Grading/Drainage
Plan

SHEET:
7

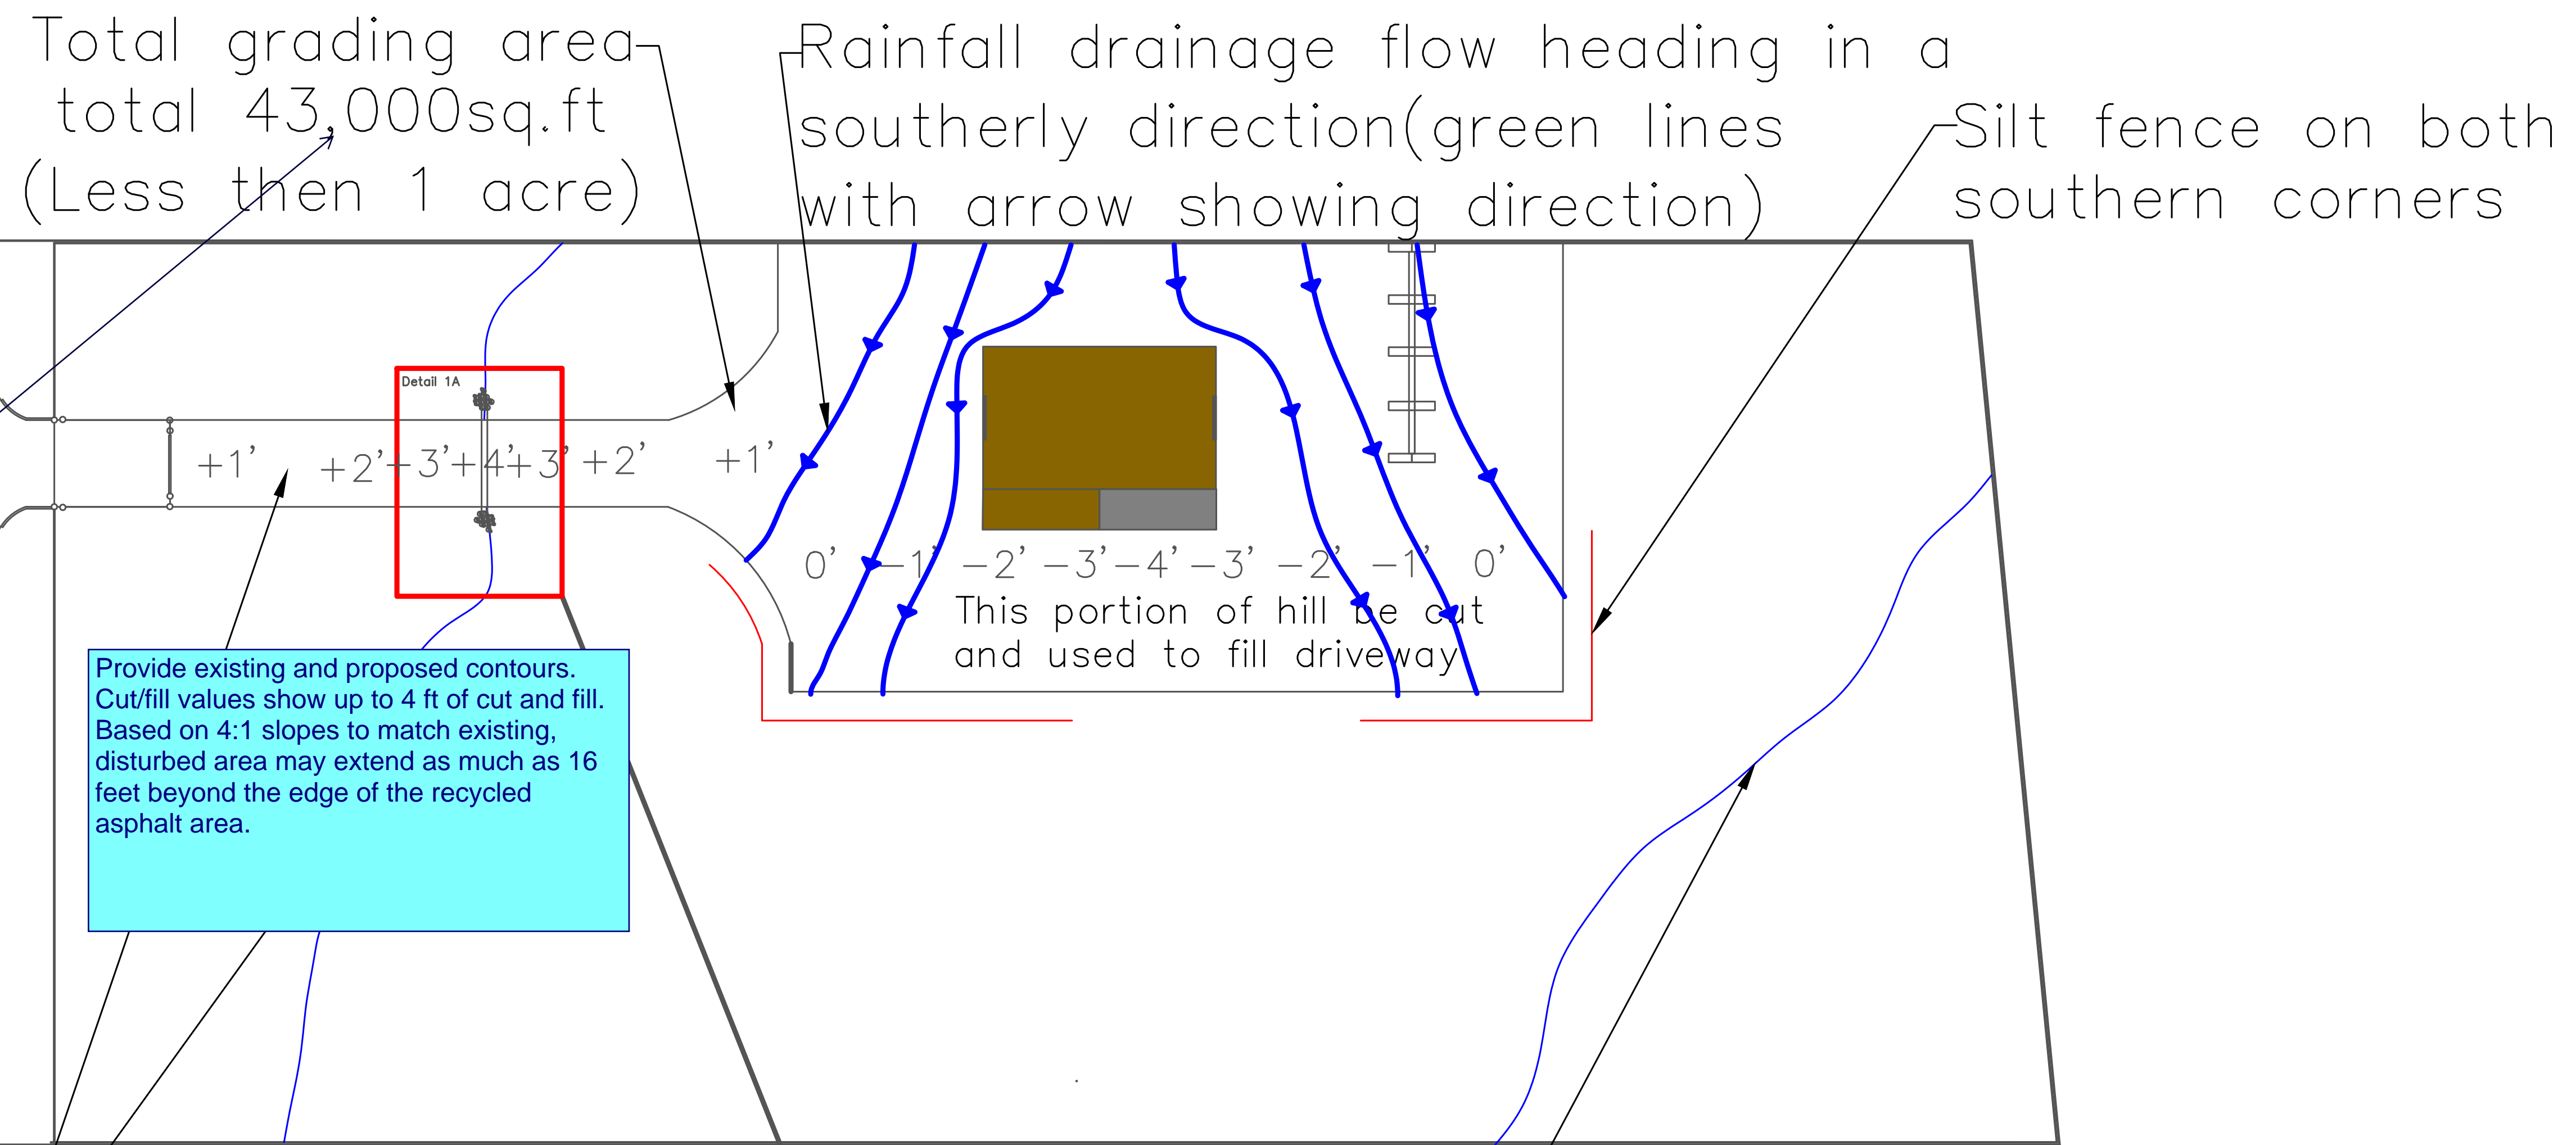
This note is not consistent with Sheet L3 which shows 1.18 acres for the recycled asphalt area.

Provide existing and proposed contours. Cut/fill values show up to 4 ft of cut and fill. Based on 4:1 slopes to match existing, disturbed area may extend as much as 16 feet beyond the edge of the recycled asphalt area.
